TRANS/WP.29/GRSP/2000/13  
11 August 2000

PROPOSAL FOR DRAFT AMENDMENTS TO REGULATION No. 94

(Frontal collision protection)

Transmitted by the Expert from Italy

Figure 1

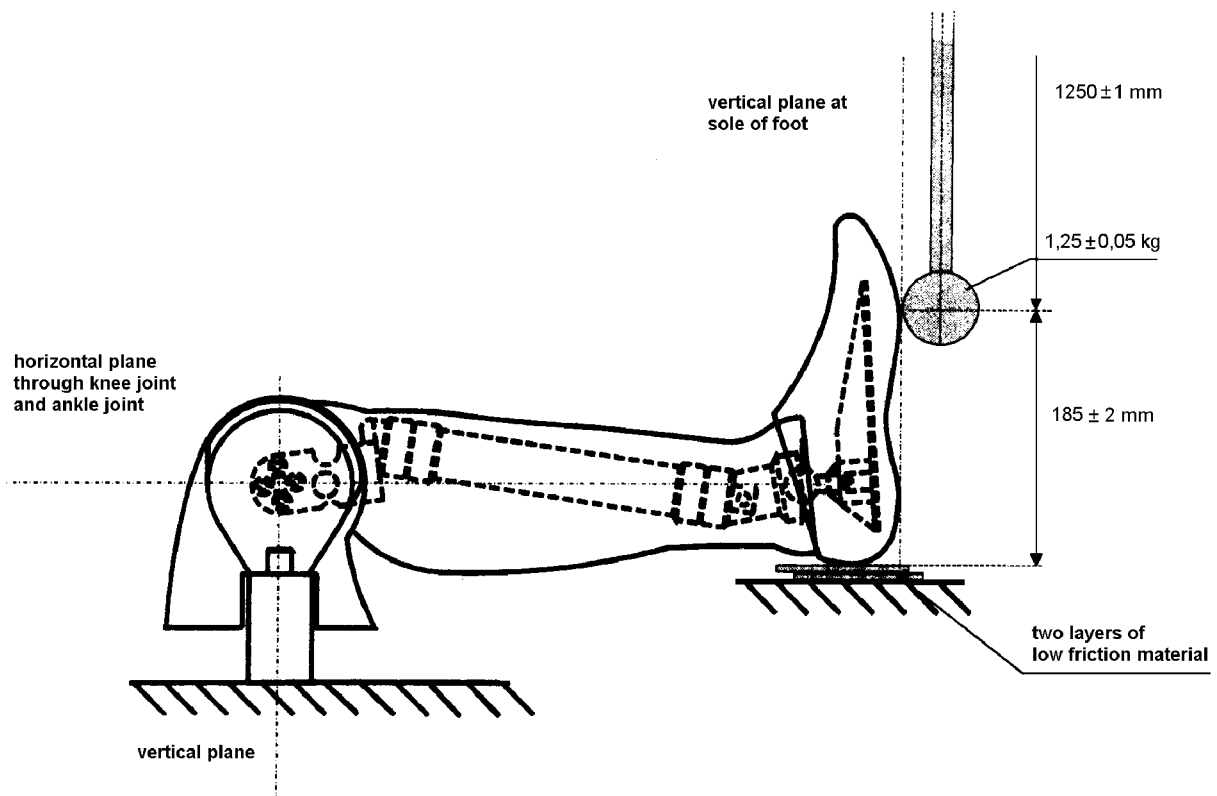
- 1.3.4. Mount the leg assembly to the fixture shown in Figure 1. The test fixture shall be rigidly secured to prevent movement during impact. The centre line of the femur load cell simulator (78051-319) shall be vertical with a tolerance of  $\pm 0.5^{\circ}$ . Adjust the mount such that

the line joining the knee clevis joint and the ankle attachment bolt is horizontal with a tolerance of  $\pm 3^\circ$ , with the heel resting on two sheets of a flat low friction (PTFE sheet) surface. Ensure that the tibia flesh is located fully towards the knee end of the tibia. Adjust the ankle such that the plane of the underside of the foot is vertical and perpendicular to the direction of impact with a tolerance of  $\pm 3^\circ$  and such that the mid sagittal plane of the foot is aligned with the pendulum arm. Adjust the knee joint to  $1.5 \pm 0,5$  g range before each test. Adjust the ankle joint so that it is free and then tighten just sufficiently to keep the foot stable on the PTFE sheet.

Figure 2

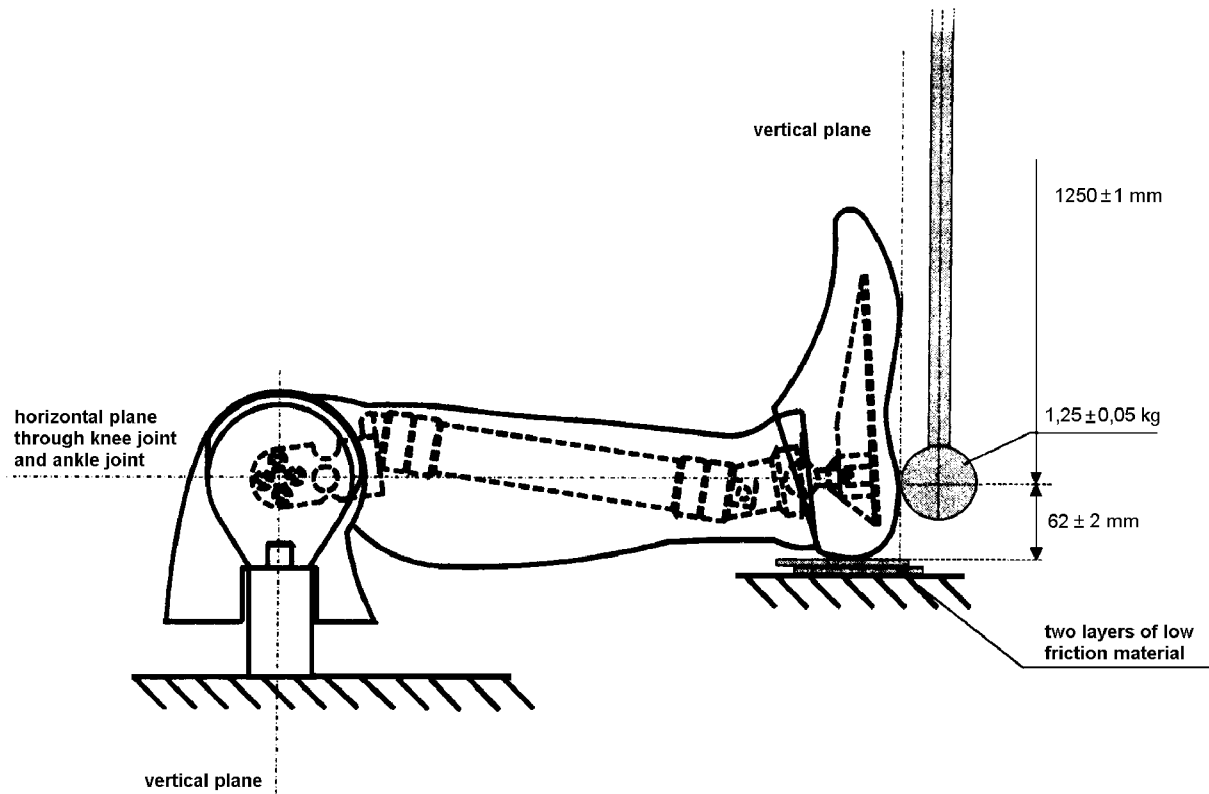
- 2.3.3. Align the impactor accelerometer with its sensitive axis parallel to the impactor longitudinal centre line.
- 2.3.4. Mount the leg assembly to the fixture shown in Figure 2. The test fixture shall be rigidly secured to prevent movement during impact. The centre line of the femur load cell simulator (78051-319) shall be vertical with a tolerance of ± 0.5°. Adjust the mount such that the line joining the knee clevis joint and the ankle attachment bolt is horizontal with a tolerance of ± 3° with the heel resting on two sheets of a flat low friction (PTFE sheet) surface. Ensure that the tibia flesh is located fully towards the knee end of the tibia. Adjust the ankle such that the plane of the underside of the foot is vertical and perpendicular to the direction of impact and such that the mid sagittal plane of the foot is aligned with the pendulum arm. Adjust the knee joint to 1.5 ± 0.5 g range before each test. Adjust the ankle joint so that it is free and then tighten just sufficiently to keep the foot stable on the PTFE sheet.

Figure 3

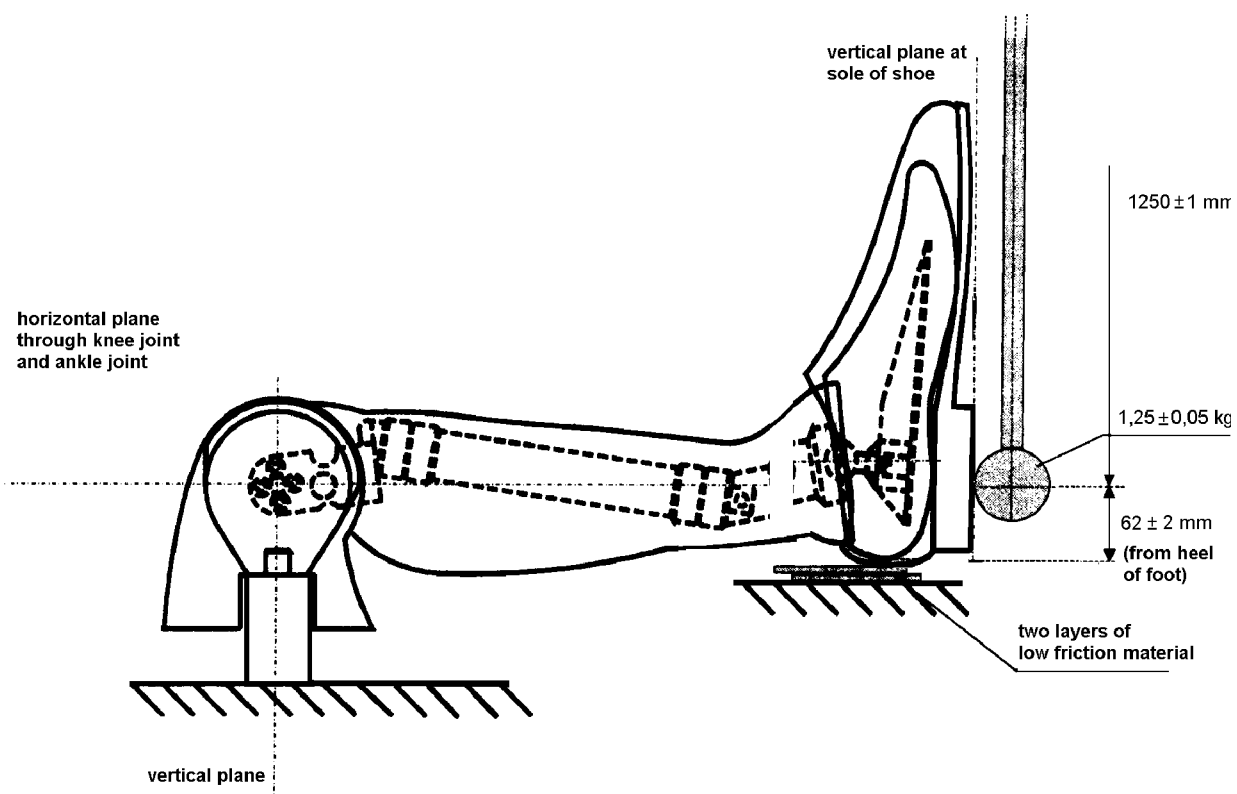
- 3.3.3. Align the impactor accelerometer with its sensitive axis parallel to the impactor longitudinal centre line.
- 3.3.4. Mount the leg assembly to the fixture shown in Figure 3. The test fixture shall be rigidly secured to prevent movement during impact. The centre line of the femur load cell simulator (78051-319) shall be vertical with a tolerance of  $\pm 0.5^\circ$ . Adjust the mount such that the line joining the knee clevis joint and the ankle attachment bolt is horizontal with a tolerance of  $\pm 3^\circ$ , with the heel of the shoe resting on two sheets of a flat low friction (PTFE sheet) surface. Ensure that the tibia flesh is located fully towards the knee end of the tibia. Adjust the ankle such that a plane in contact with the heel and sole of the underside of the shoe is vertical and perpendicular to the direction of impact with a tolerance of  $\pm 3^\circ$  and such that the mid sagittal plane of the foot, and shoe is aligned with the pendulum arm. Adjust the knee joint to  $1.5 \pm 0.5$  g range before each test. Adjust the ankle joint so that it is free and then tighten just sufficiently to keep the foot stable on the PTFE sheet.
